FACILITY: Millstone Nuclear Power Station, Unit 2

SUBJECT: SUMMARY OF MEETING WITH NORTHEAST NUCLEAR ENERGY COMPANY ON  
MASONRY WALL DESIGN

NRC/NUSCO MEETING  
SEPTEMBER 27, 1984  
MILLSTONE UNIT NO. 2

REEVALUATION PROCEDURE

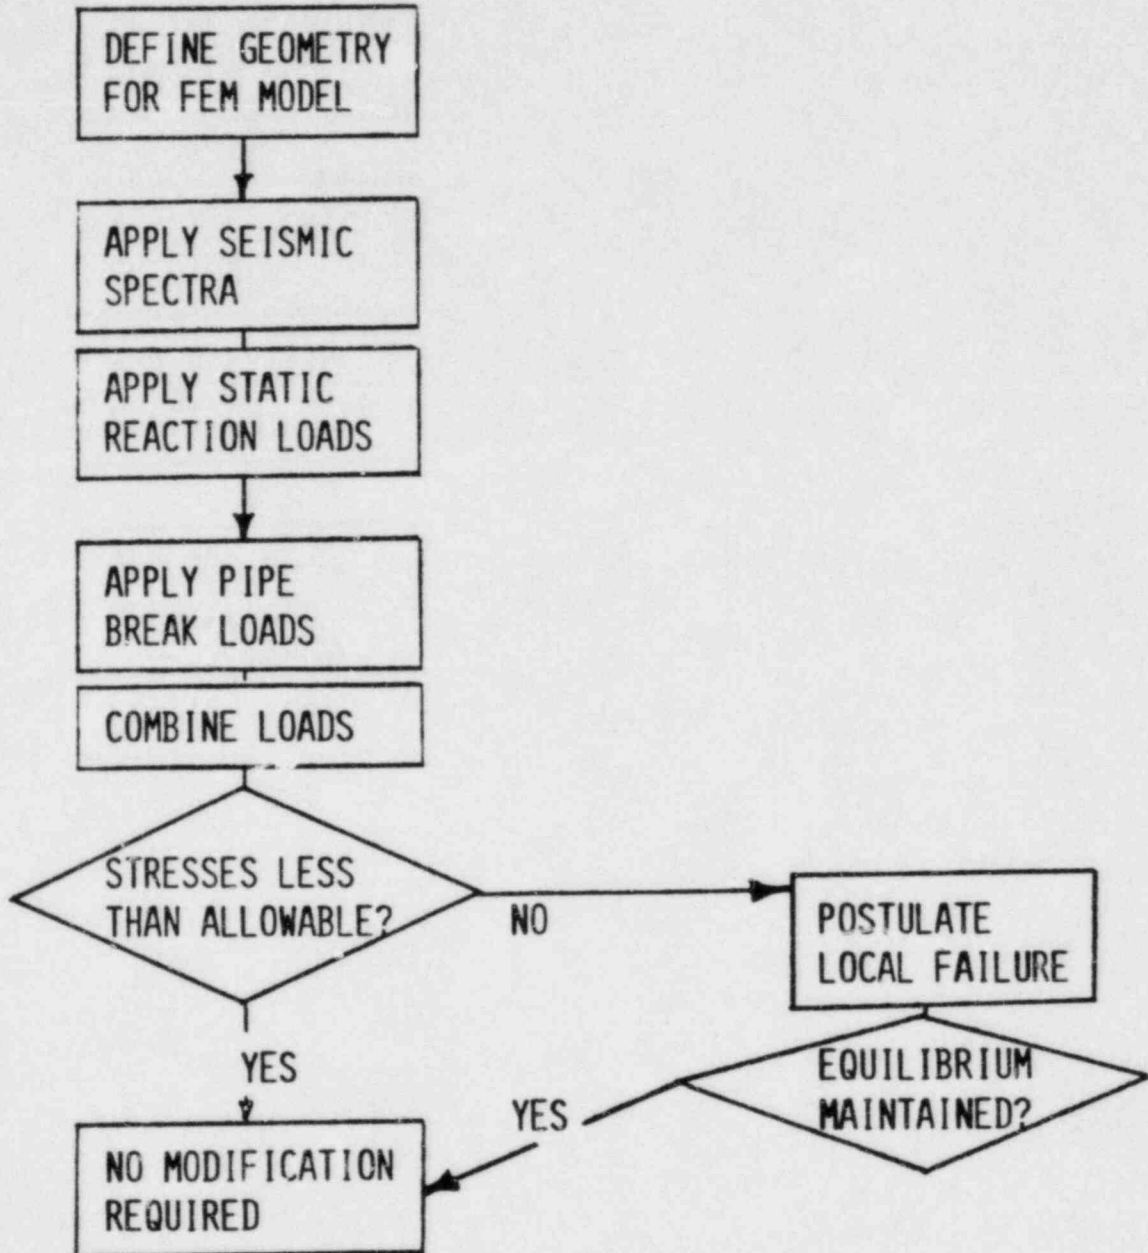
With regard to the nonlinear analysis technique (energy balance technique and arching action theory), please note the following and provide the information requested.

- a. Arching Action: The NRC position on this issue states that the use of the arching action theory to qualify unreinforced masonry walls is not acceptable. These walls should be repaired so that they can be qualified based on the SGEB criteria (3). (The NRC position is attached.) In view of this, indicate your intended actions and schedule to bring the affected walls in compliance with the staff position.
- b. Energy Balance Technique: The NRC is currently preparing a position statement regarding this technique, which will be forwarded to the licensee in the near future.

##### ASSUMPTIONS

- o ALL COMPONENTS OTHER THAN PIPING SUPPORTED ON OR NEAR MASONRY WALLS ARE CONSIDERED RIGID AND THEREFORE DO NOT IMPOSE AMPLIFIED LOADS OR IMPACT LOADS ON THE WALL DUE TO SEISMIC DISPLACEMENT

- o PIPING REACTION LOADS ARE STATICALLY APPLIED AND ADDED TO INERTIAL LOADS. THE MASS OF THE ATTACHED PIPING IS ALSO INCLUDED IN THE INERTIAL CASE

- o SURFACE MOUNTED ATTACHMENTS WHICH PROJECT NO FURTHER FROM THE WALL SURFACE THAN THE WALL THICKNESS CONTRIBUTE ONLY IN-PLANE LOADS TO THE WALL

- o SUPPORT CONDITIONS FOR MASONRY WALLS ARE CONSIDERED PINNED WHEN SHEAR TRANSFER MECHANISMS ARE PRESENT; OTHERWISE, A FREE EDGE IS ASSUMED

- o MULTI-WYTHE WALLS ARE ANALYZED AS MULTIPLE SINGLE WYTHE WALLS TAKING NO CREDIT FOR COLLAR JOINT MORTAR SHEAR CAPACITY

- o A DYNAMIC LOAD FACTOR (DLF) OF 2 IS USED TO AMPLIFY THE JET IMPINGEMENT LOADS
